# 1ST & PIKE

103 PIKE STREET

EARLY DESIGN GUIDANCE 3  
03 APRIL 2018  
DPD #3028428

## 1. ARCHITECTURAL CONTEXT - STREET SECTIONS

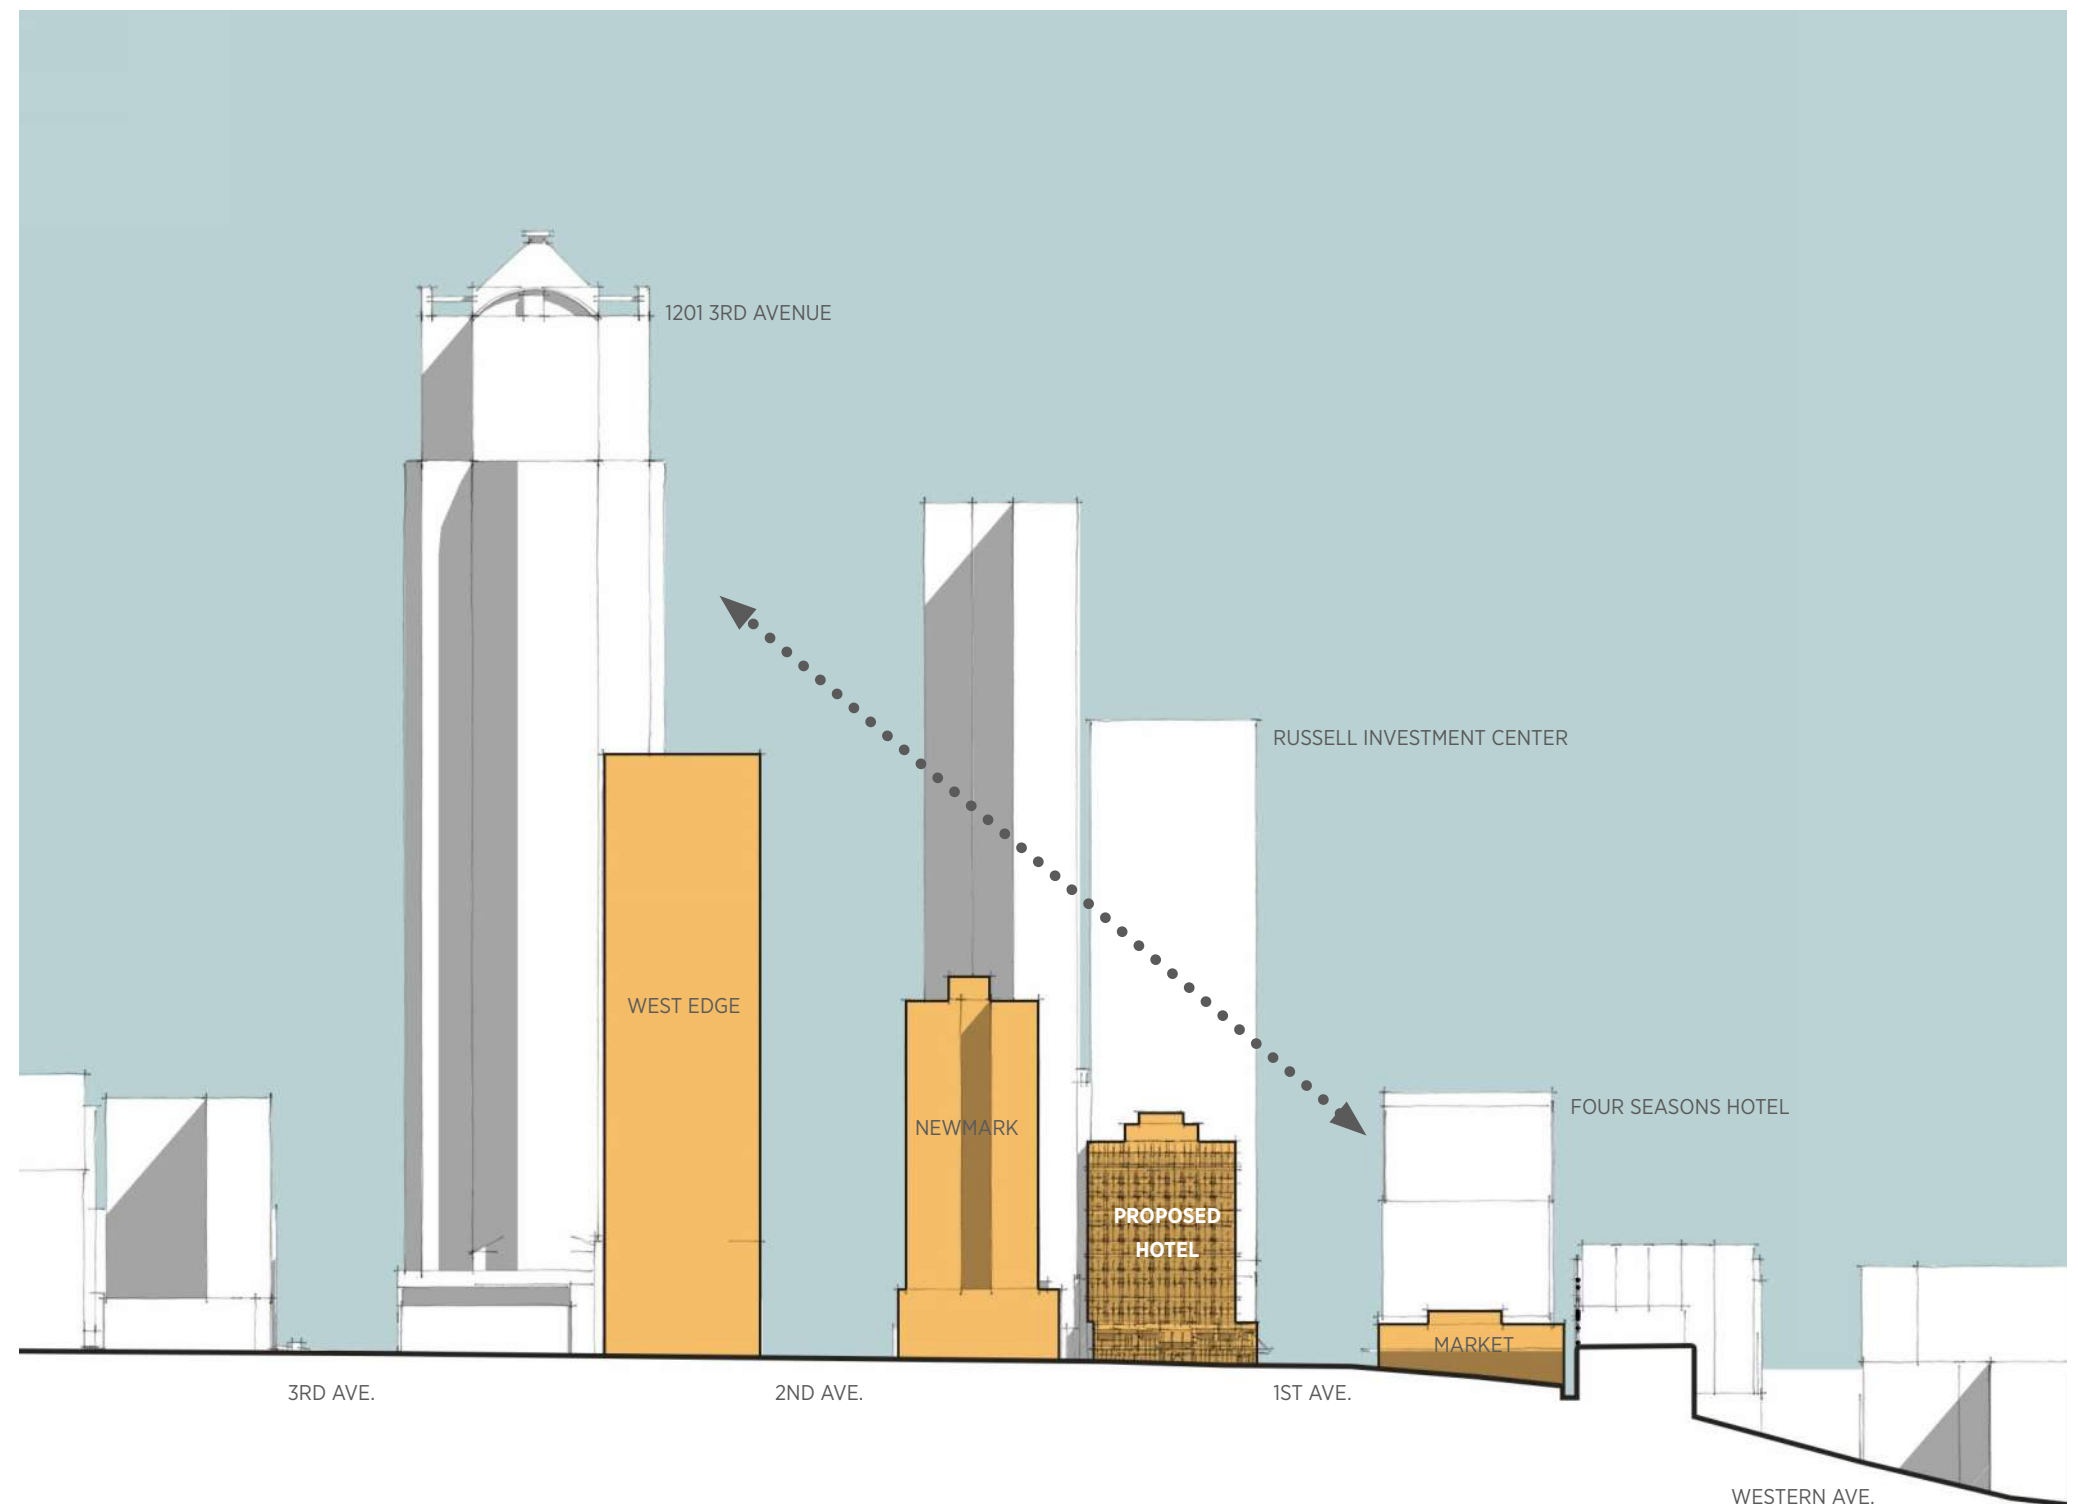
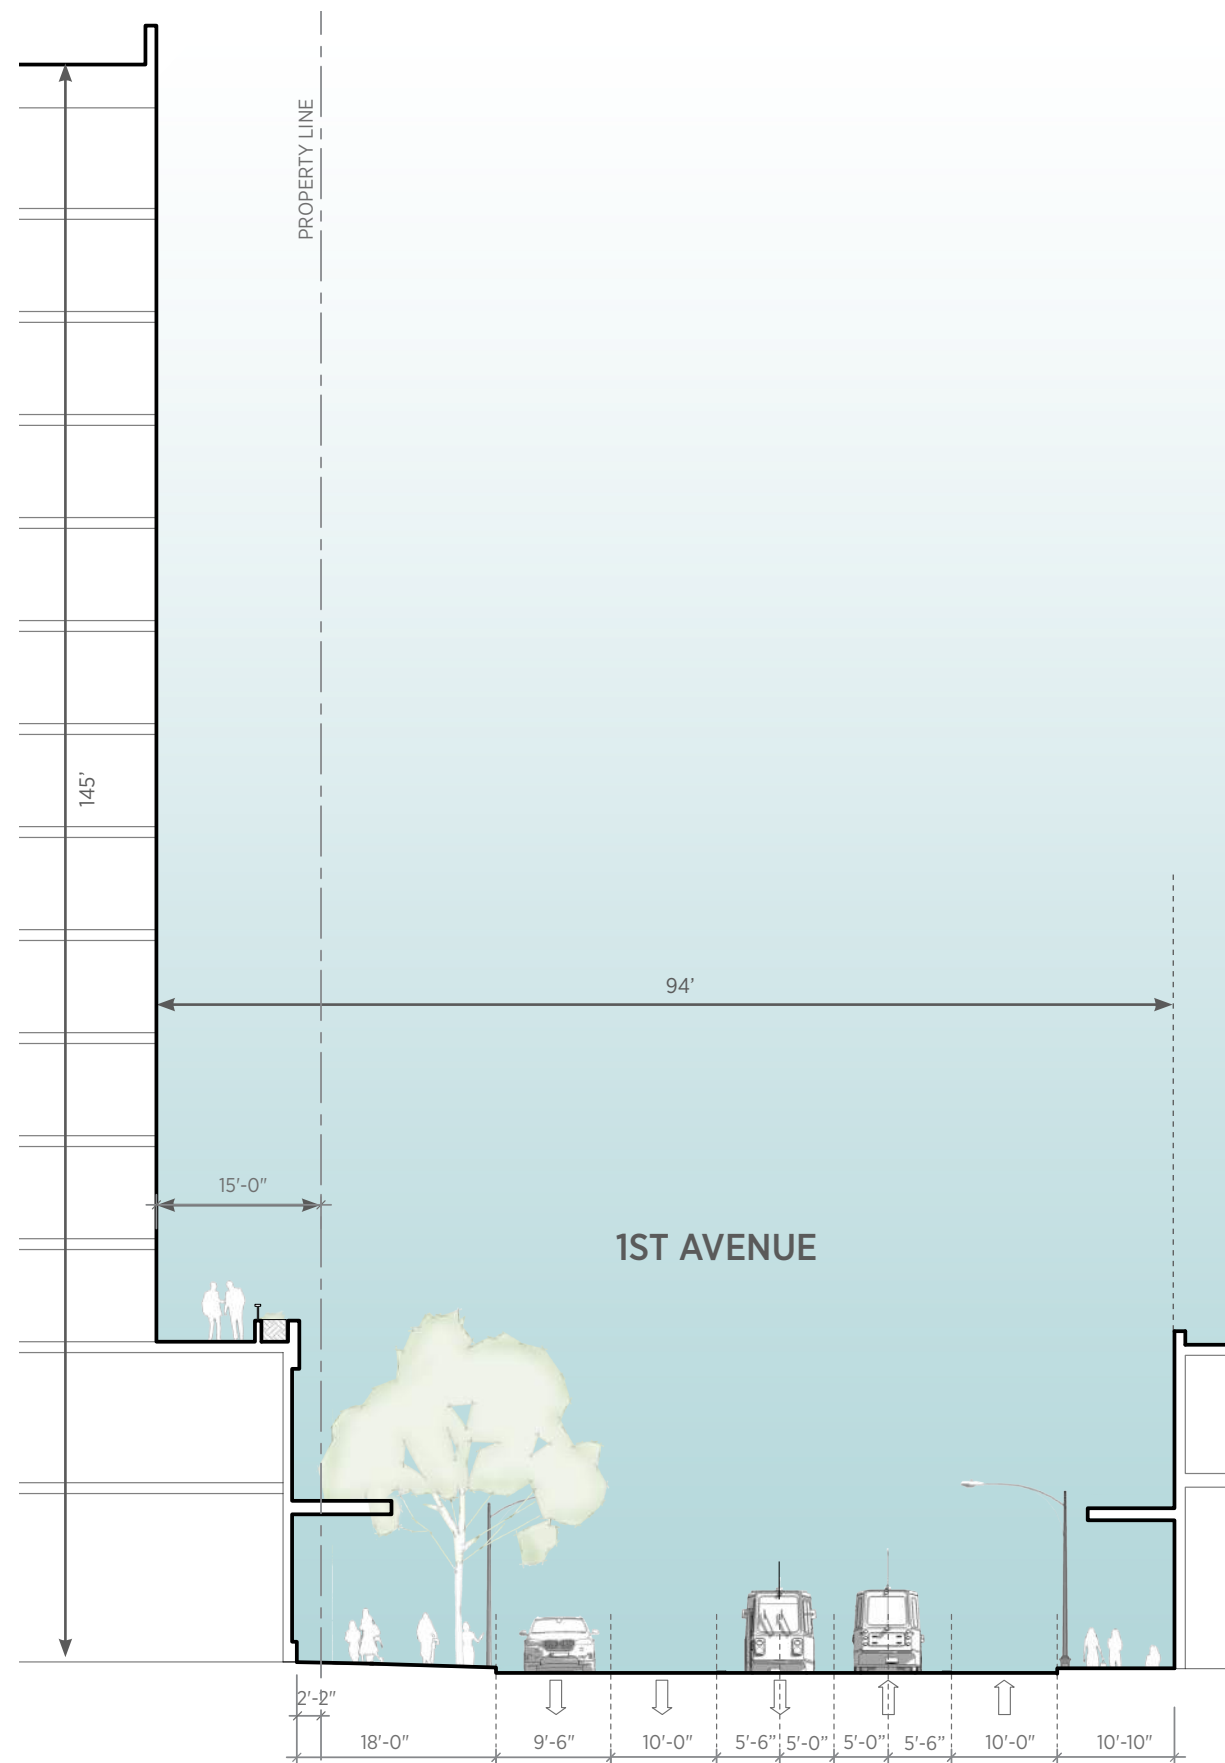
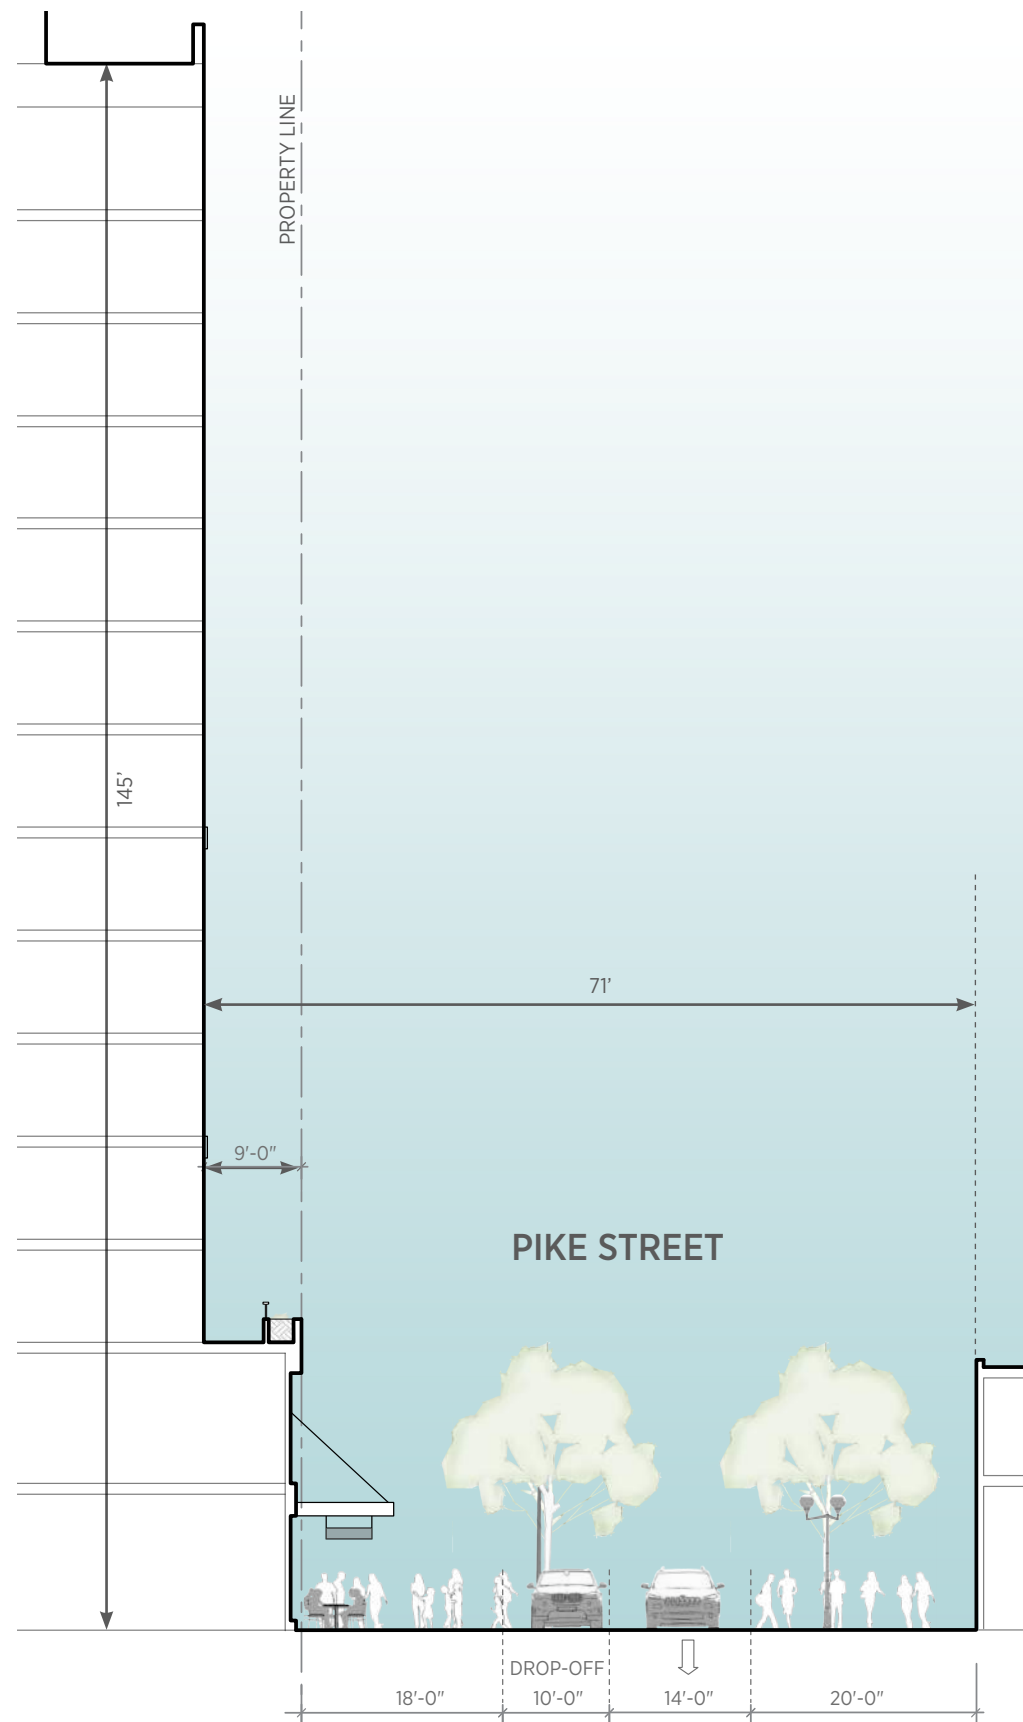
*1.a.i The Board requested that additional context analysis information be provided in the design packet and presented at the next EDG meeting:*

- Street section through Pike Street; and
- Street section through 1st Avenue.

In addition to the street sections, the design team has provided an East-West section through Pike Street showing the planned massing transition from 3rd Avenue to Western. The proposed hotel at 1st and Pike honors the scale intended by the city planners.
